Deviation From Design

DfD-0020

**Taran Laval – SAAA Builder 7417
Van's Aircraft RV7 - 73918**

LH WING MAIN RIB TO FWD SPAR DAMAGE

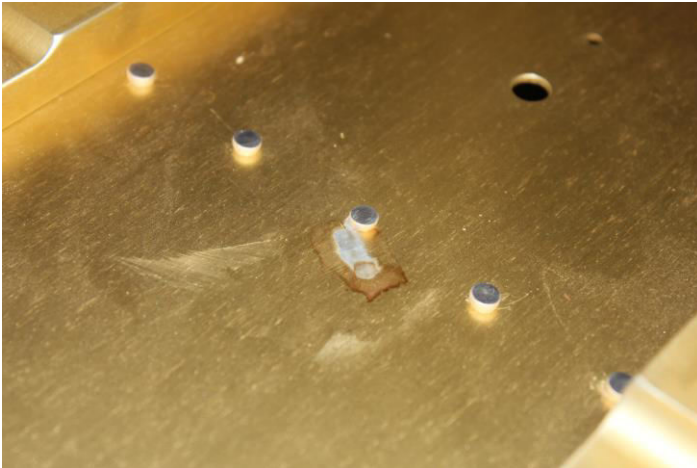
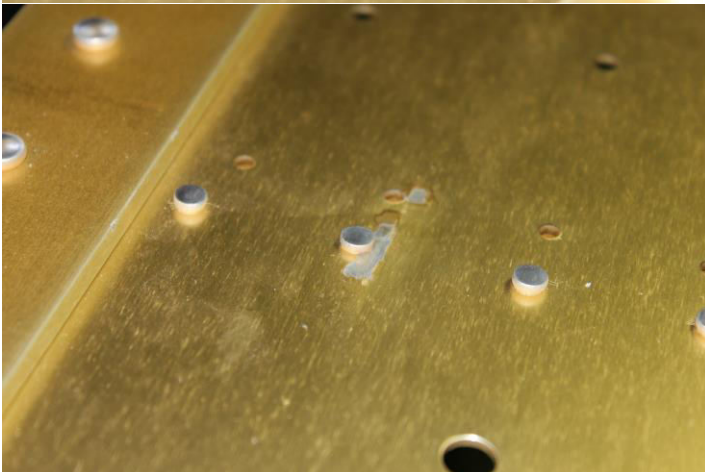
DURING WING RIB TO MAIN SPAR RIVETING THE BUCKING BAR SLIPPED AND CONTACTED SPAR CAUSING A SMALL SCRATCH IN TWO LOCATIONS

- RIB 5 CENTER RIVET
- RIB 9 SECOND RIVET FROM BOTTOM

RIVETS REMOVED SMALL SCRATCHES BLENDED/SPOT ALODINED AND RIVETS REINSTALLED
